SP1 to SP1F Module Package Data Sheet Clarification Errata

SP1 TO SP1F MODULE PACKAGE

SUMMARY OF CHANGE

The package was changed from SP1 to SP1F.

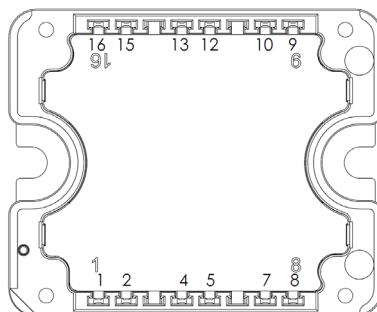
Refer to Application Note AN3500 "Mounting Instructions for SP1F and SP3F Power Modules." The pinout location diagram is replaced by this drawing.

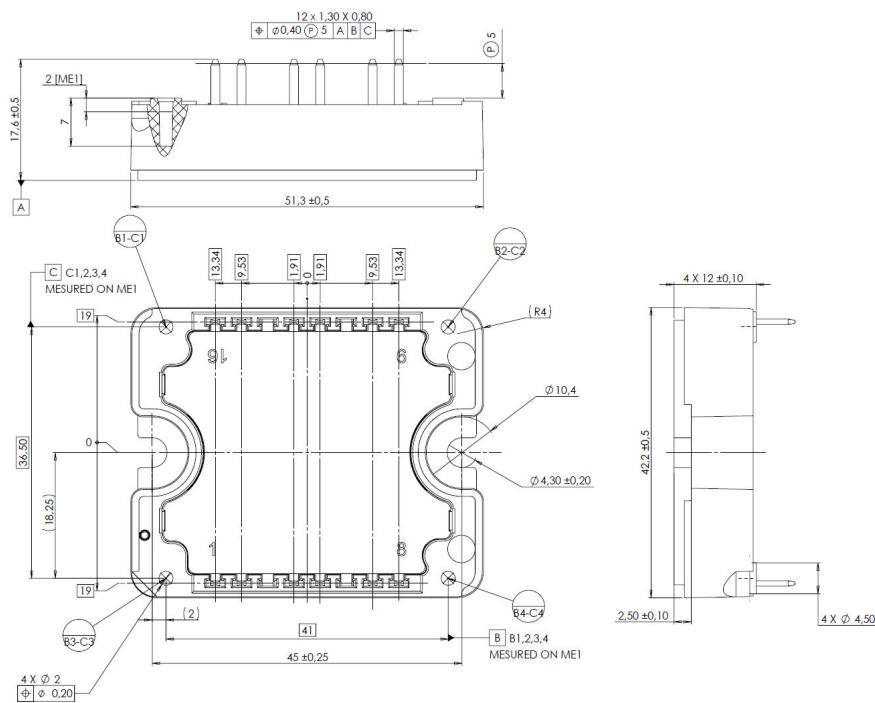
The package outline drawing is replaced by this drawing. The dimensions in the following figure are in millimeters:

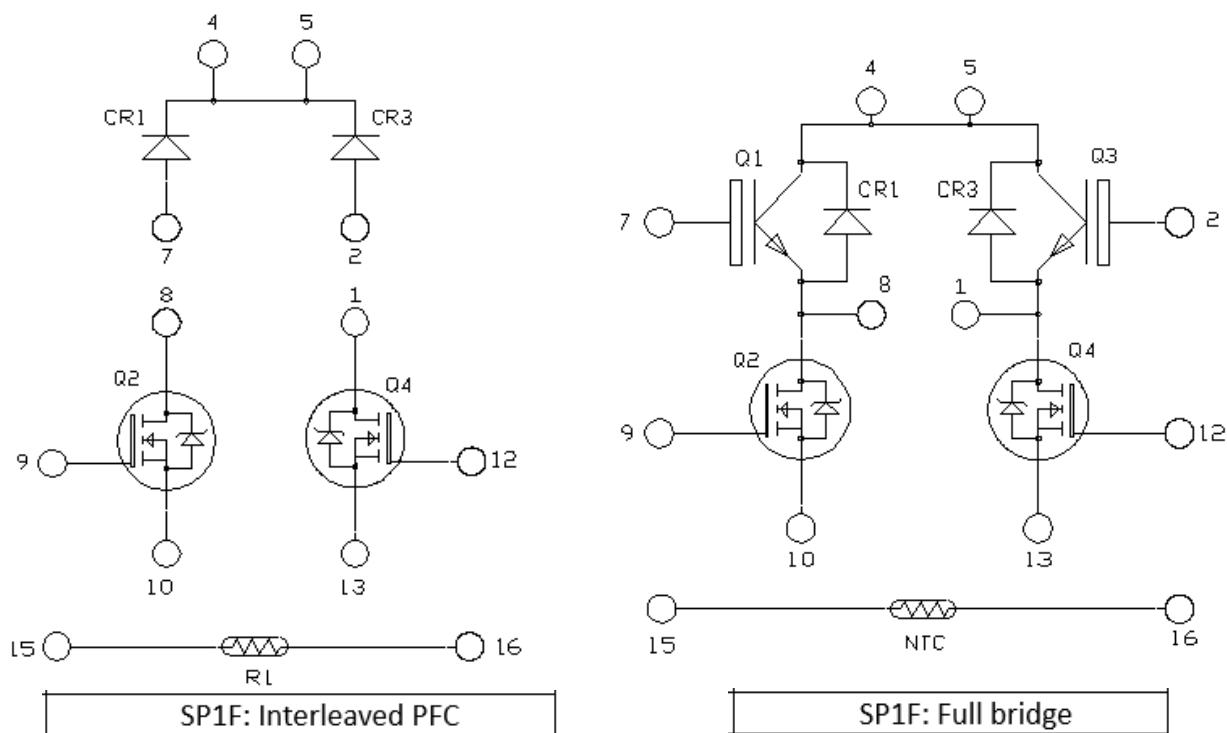
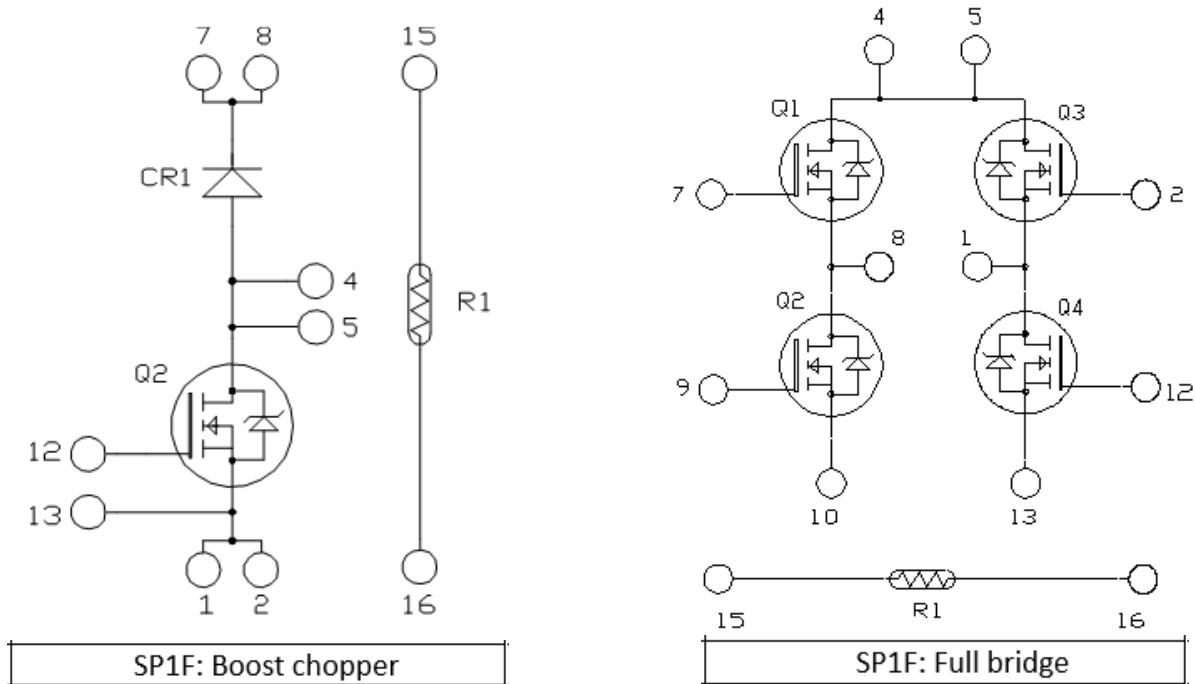
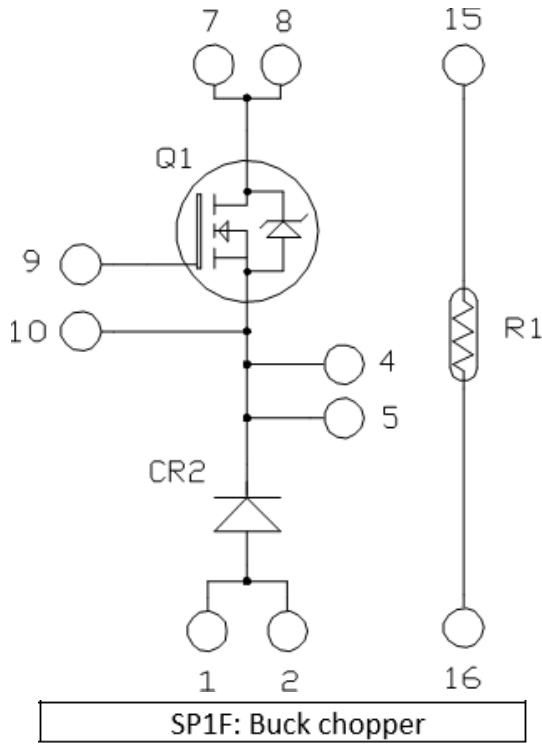
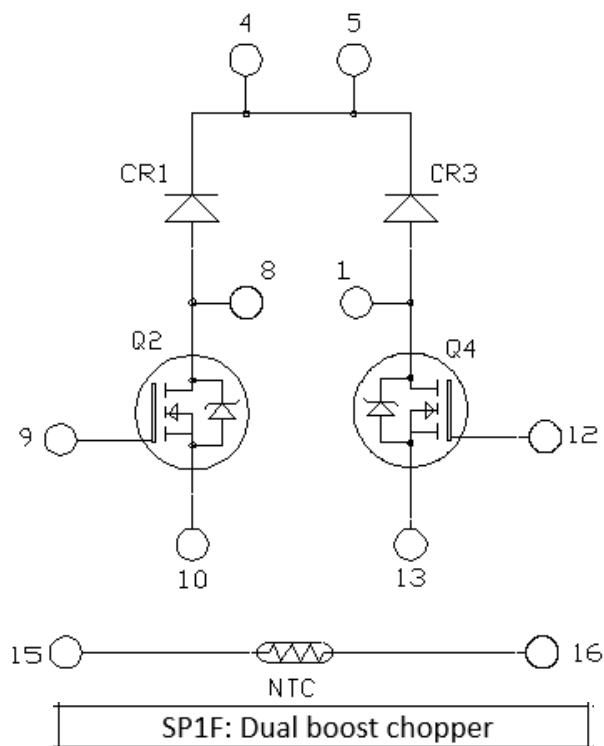
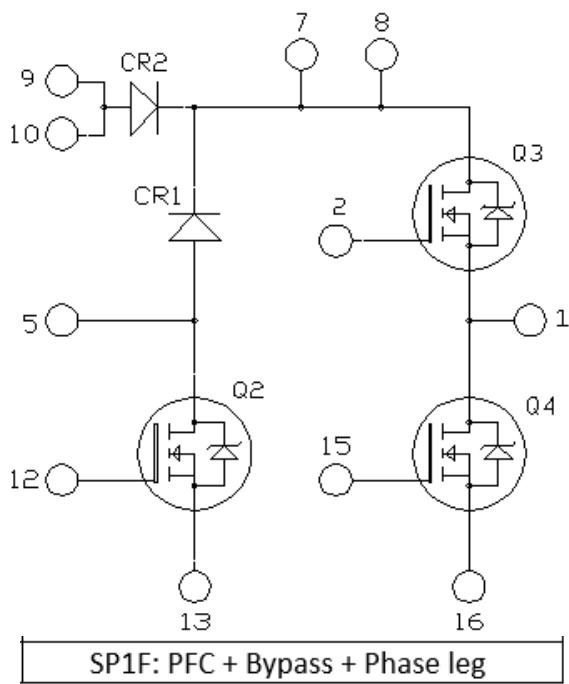
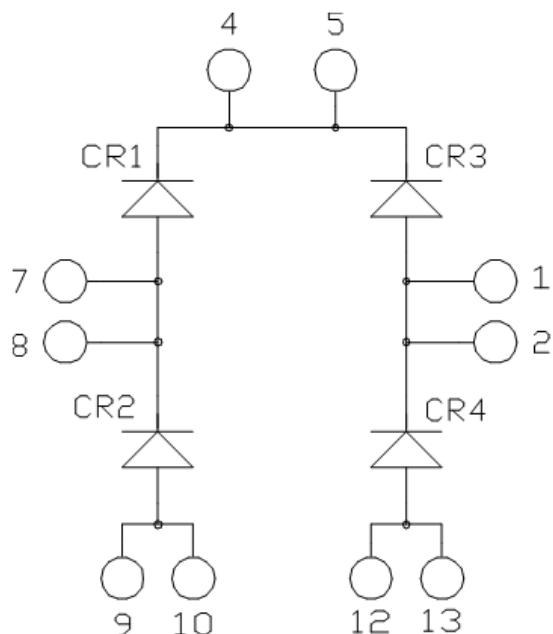
The Package schematic is replaced by this drawing, based on part configuration.
